Documenting the Appropriate UFLS Requirements Applicable to EKPC

Denise Foster Cronin, EKPC
PJM Members Committee – May 10, 2022

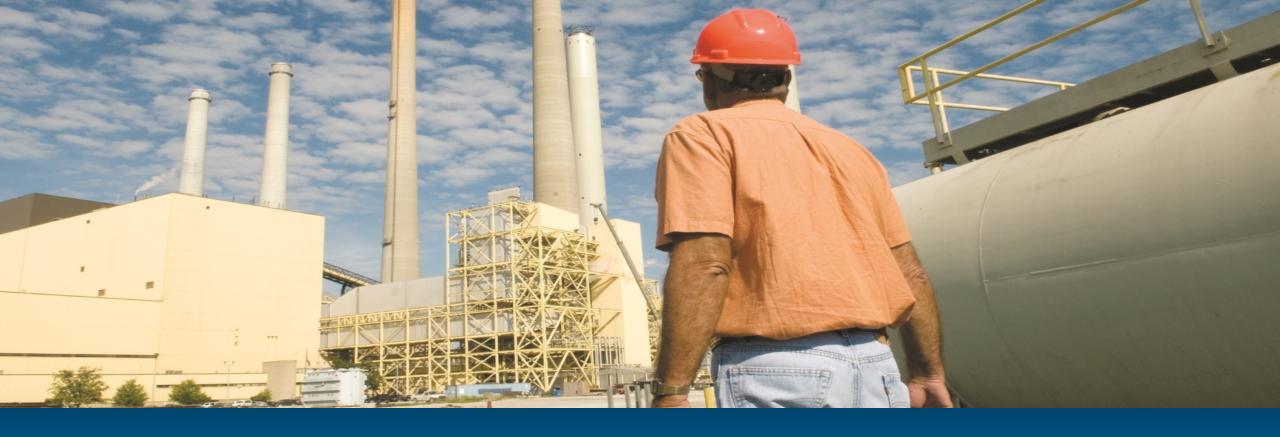
Proposed Recommendation to Remedy Oversight & Unintended Confusion

Implement proposed changes necessary to formally document the applicable UFLS requirement for EKPC consistently within PJM.

Proposed draft PJM OA, Schedule 7 language revisions supporting the endorsed solution will be taken to the MRC and MC for consideration and voting. Conforming Manual 36 revisions will proceed through the OC at a later time.
